Doc. No.: MD10-WOI-77-001
Type: JS-MD Single	Subject: Service Bulletin	ATA: 77-20
Model/s: JS-MD 3	Title: Work Instructions for EGT Sensor Location Correction	Rev.: 00

Title:	Work Instructions for EGT Sensor Location Correction
	Service Bulletin

This document contains all necessary steps to complete the content of the Service Bulletin SB-MD10-001.

Figure 5-2: Jet Engine Assembly; Front cover not depicted

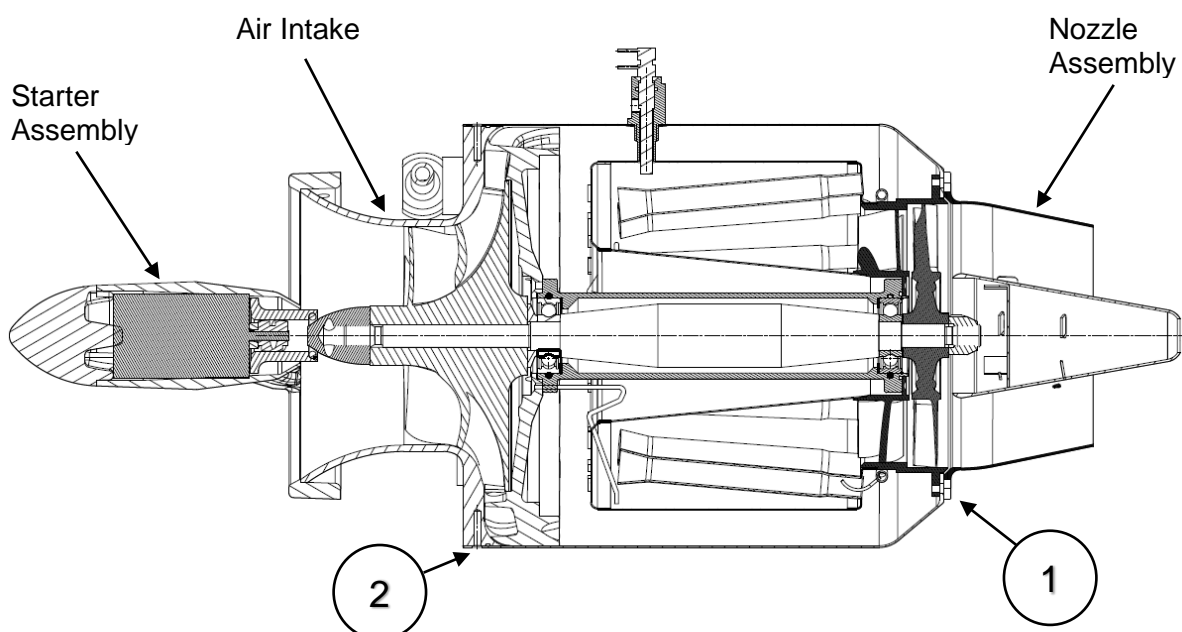
1. Loosen the clamping nut of the EGT Sensors at the Nozzle assembly and pull out the Sensor tip.
2. Remove all 12 pcs. M3x10 cap screws DIN 912 (04-682) and 12 pcs. washers at Position 1 in Figure 5-2 and remove the nozzle.

1. The nozzle is turned by 90° to the left, when looking from the back to the front (The EGT Sensor Retainer is pointing towards the sky respectively 12 o'clock position).
2. Screw the nozzle with 12 pcs. M3x10 cap screws DIN 912 (04-682) and 12 pcs. washers crosswise with the 1.3 Nm torque. Use Loctite 243 to secure the screws.

1. Loosen the EGT Sensor support bracket at Position 2 at Figure 5-2.
2. If needed, remove the Cables of the EGT sensor from the Sensorboard.
3. Plug the sensor into the EGT sensor retainer at the new position and tighten the nut.
4. By bending, the sensor wire will be routed along the housing, where later the pylon of the engine shroud is located, see Figure 5-3.

Figure 5-4: Sensor connection on sensor board

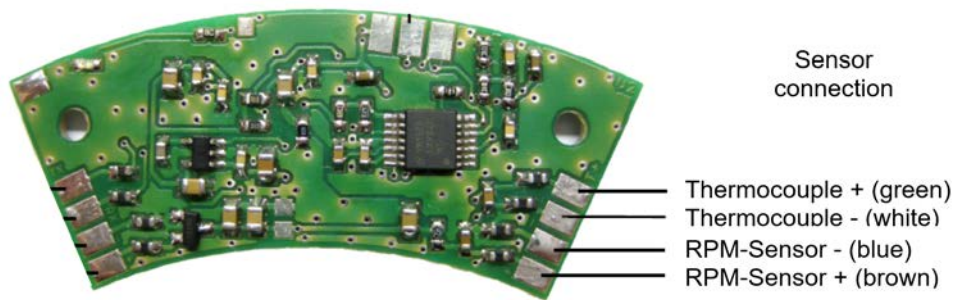
5. Fix the EGT sensor cable with the cable harness using cable ties.
6. Connect EGT Sensor wire to the Sensorboard acc. to Figure 5-4, if disconnected before.
